Addendum No. 2

RFT 24-061 Gymnasium Addition - Glenview Public School

ADDENDUM #1

Project	Glenview PS Gym Addition	Project No.	2314
Location	143 Townsend Ave., Burlington, ON	Date of Issue	2024 05 17
Owner	Halton District School Board	File	2314/7.1.3

PARTIAL FLOOR & ROOF PLAN - NEW & RENO

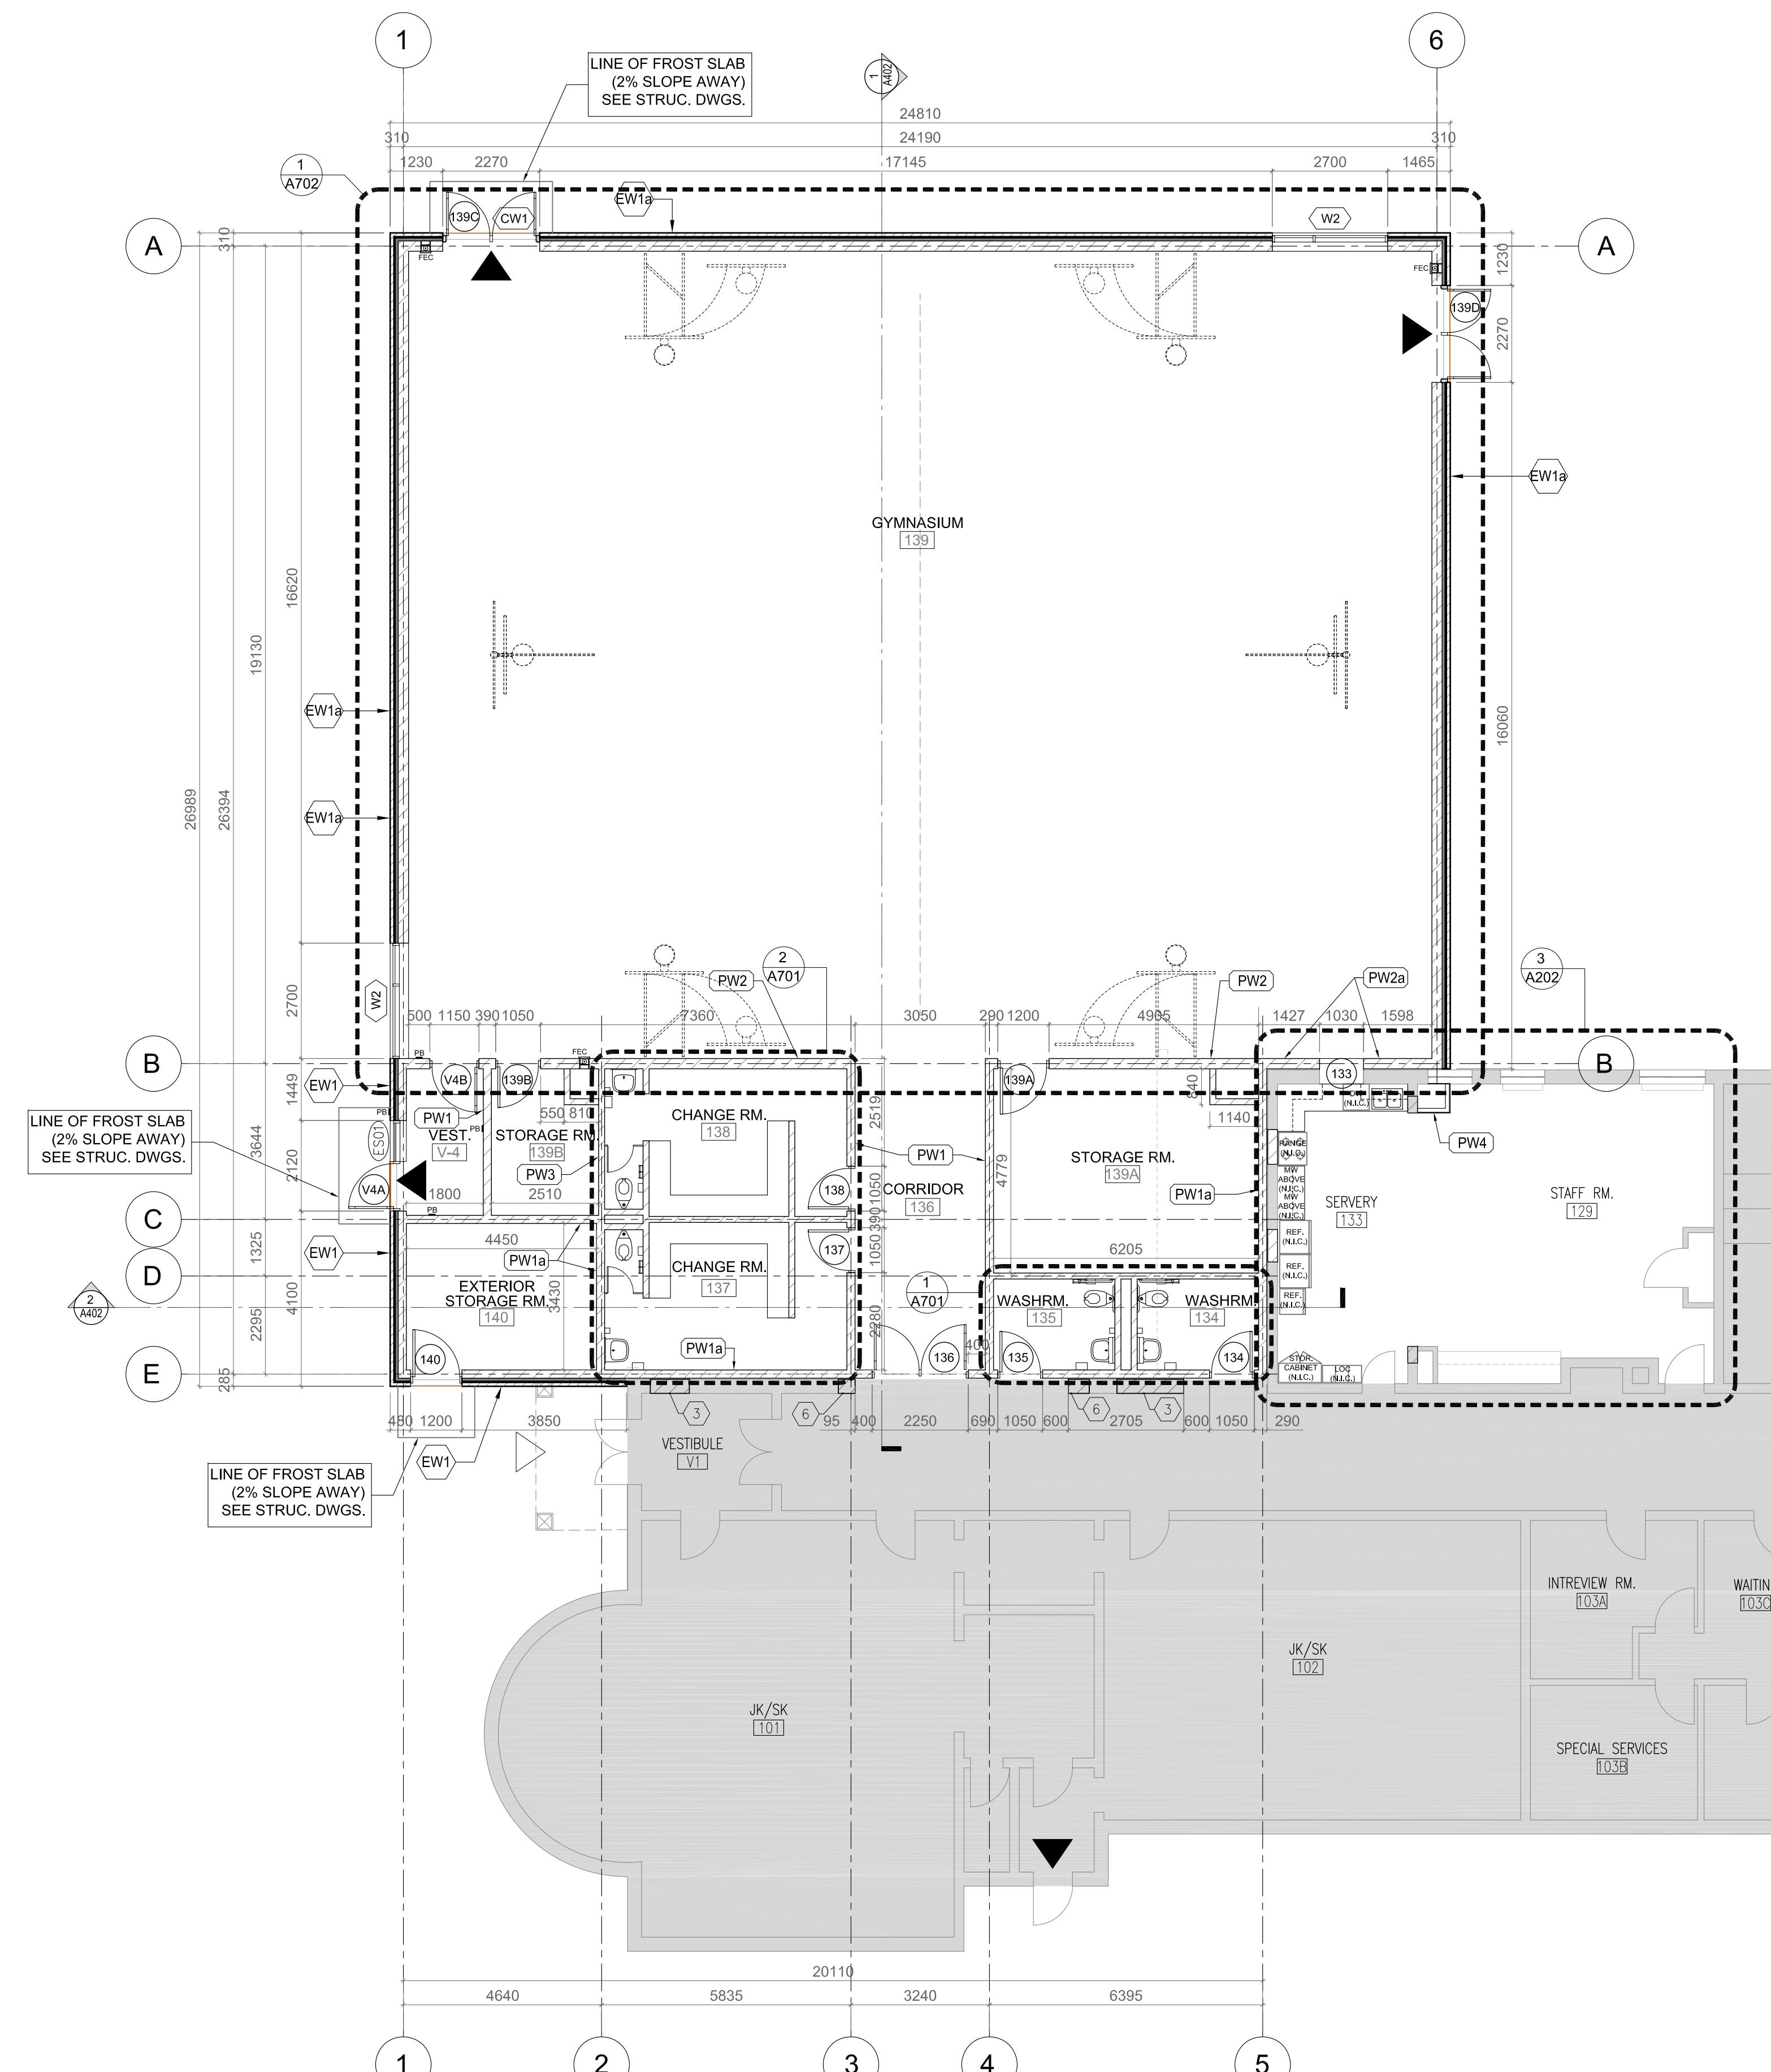
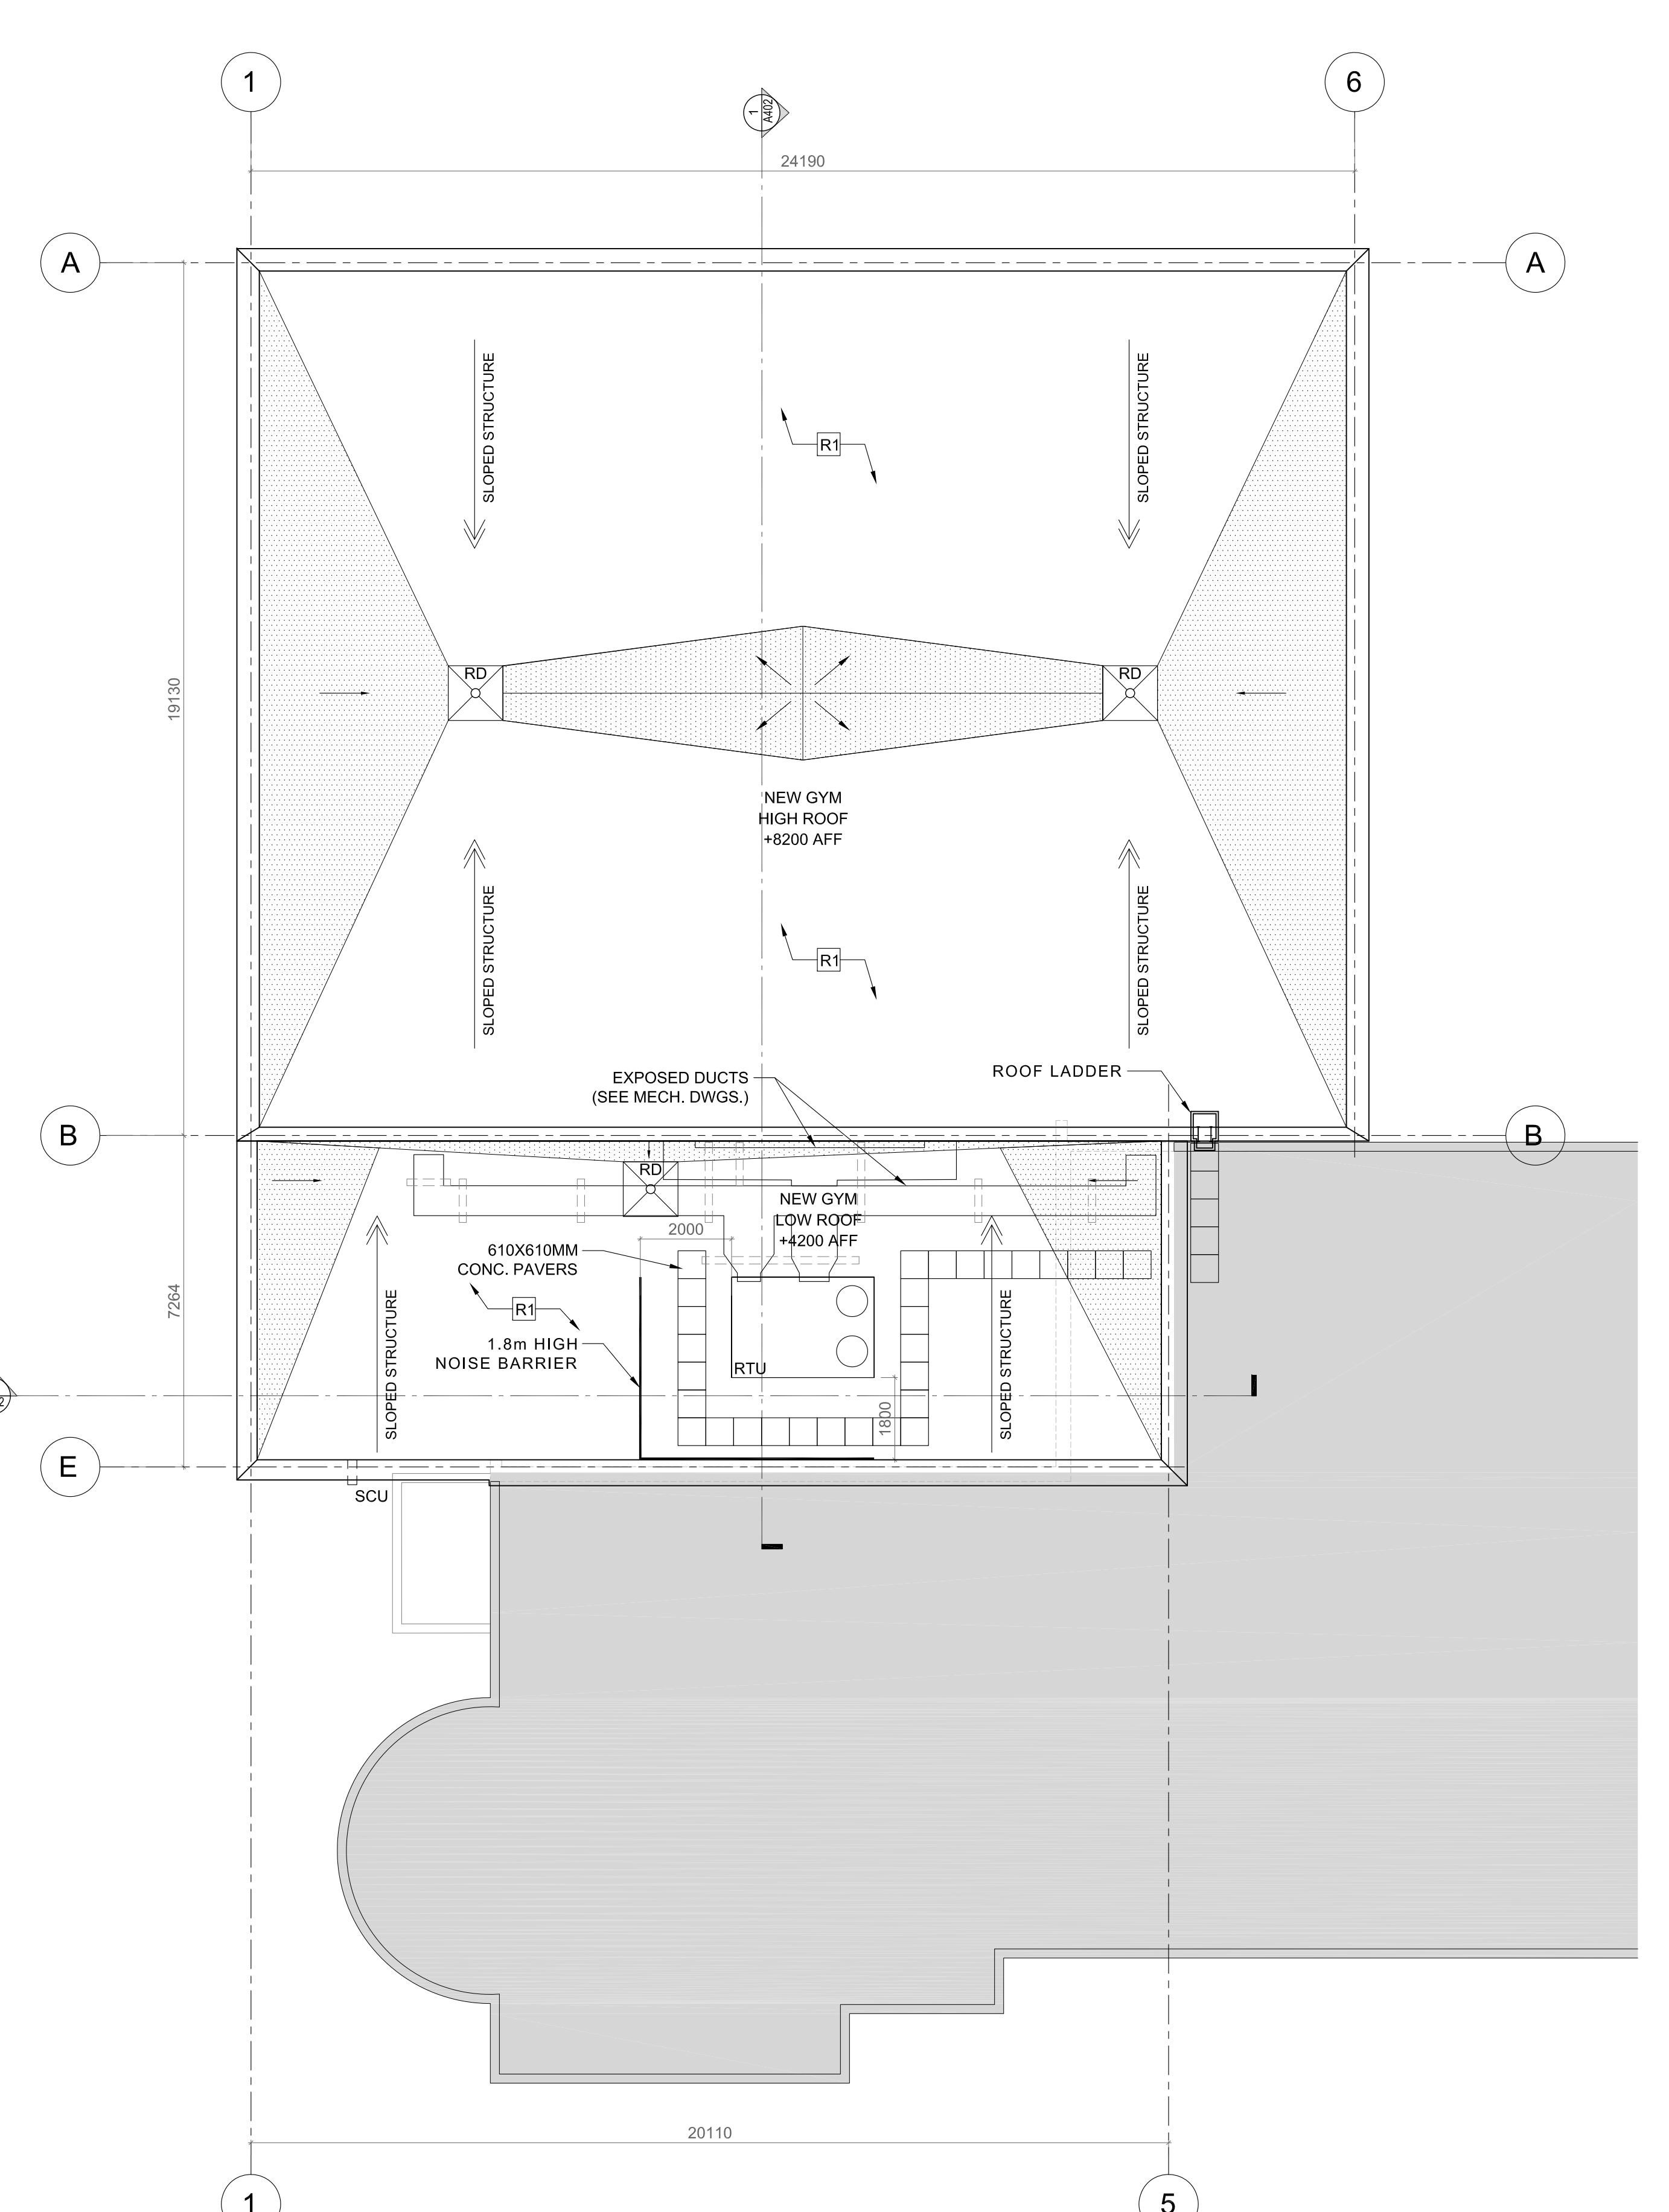
A1-4 DRAWING A202 PARTIAL FLOOR & ROOF PLAN – NEW & RENO

- .1 Replace Drawing with the attached Revision No. 4.
- .2 Drawing reissued to revise roof type legend to match specifications.

- (R1) BAL-TUP BITUMINOUS ROOFING SECTION 07 81 00
GRAVEL SURFACE FINISH (HOT APPLIED FLOOD COAT),
4.5 TYP. 6 FLETS WITH 1.6L COMPOSITE FELT WITH
HOT APPLIED INTER-PLY ADHESIVE
120mm COVER BOARD
TAPERED INSULATION (INS-PR-3) WHERE REQUIRED
100mm FLAYERS MFL-ROOF INSULATION (INS-PR-3)
VAPOUR RETARDER
120mm UNDERLAY BOARD
METAL DECK
STEEL ROOF STRUCTURE - SLOPE ACCORDING TO ROOF PLAN
